PUBLIC INTEREST REVIEW FOR GROUNDWATER APPLICATIONS

SUBJECT: Application G- 17437 Supersedes review of January 12, 2011 Date of Review(s)

A. GENERAL INFORMATION: Applicant's Name: Jennifer & Eric Miller County: Wasco

Groundwater Application G-17437, Miller Wasco County, Dufur West Quad

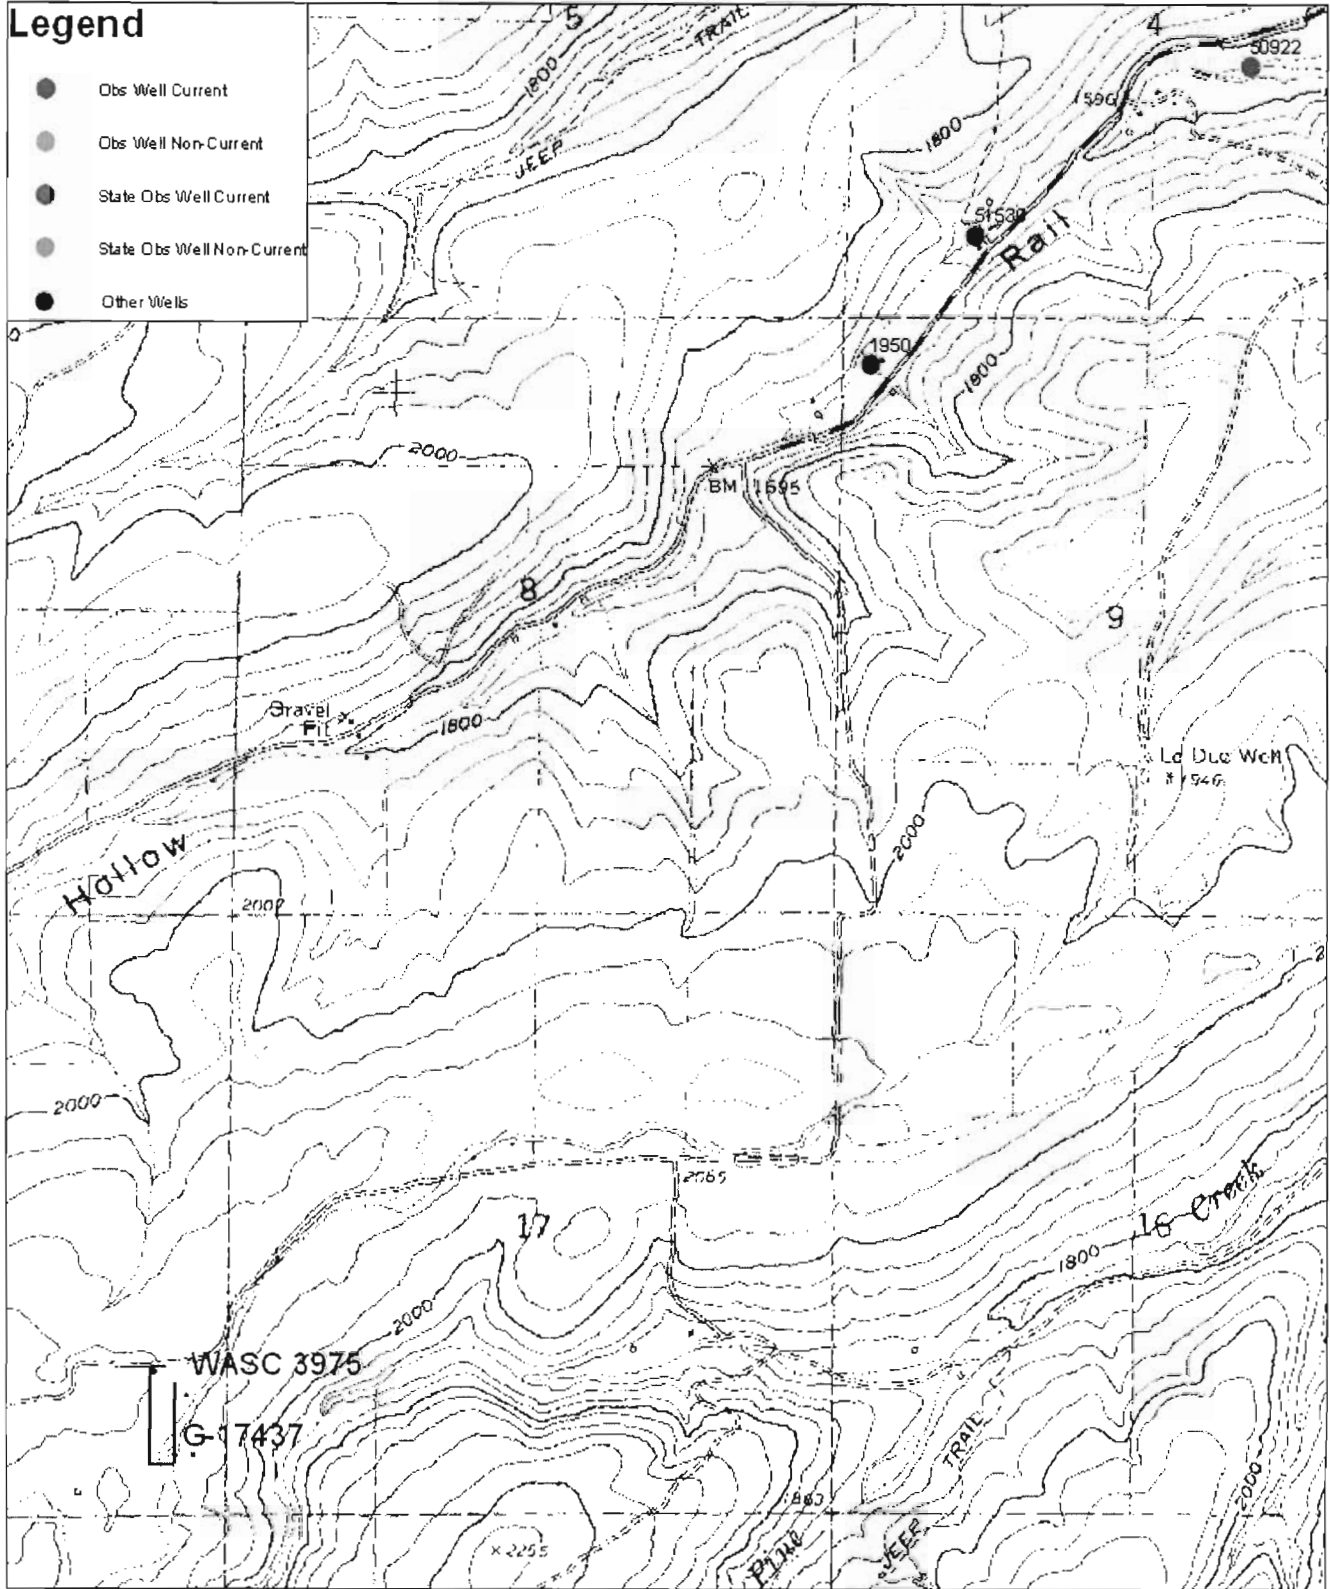
B3. **Groundwater availability remarks:** A water level was measured at well #1 (WASC 3975) on January 10, 2011. The January water level was lower than the water level reported on the well log by about 8 feet. The water level was 101 on 6/13/1979. The amount of decline is probably greater than 8 feet when corrected for the difference in seasons of the measurements. A well, WASC 1950, located about two miles northeast was recently deepened because the water level had declined about 49 feet in from 8/16/1991 to 8/23/2010. When deepened, the well penetrated a deeper aquifer with a water level about 50 feet lower. See Graph. WASC 3975 develops water from a different aquifer than WASC 1950.

The applicant has requested a second POD with a proposed depth of 320 feet, 105 feet deeper than the existing well. It is not unusual for wells to encounter different aquifers with increasing depth in this area. There are substantial declines in some aquifers in this area. If a new well is constructed or the existing well is deepened, a different aquifer may be encountered. There is a well under construction about ½ mile south of the applicants (as of early February). The well is about 1000 feet deep without encountering water.

Well Construction Condition: Well #1 shall not be deepened into a different aquifer. Well #2 shall be completed in the same aquifer as Well #1.

The applicant requested an increase fro 10 gpm to 70 gpm. The original review found water available a 10 gpm. At 70 gpm, considering the overall trend in groundwater levels in this area is down, the resource can not sustain the additional 60 gpm.
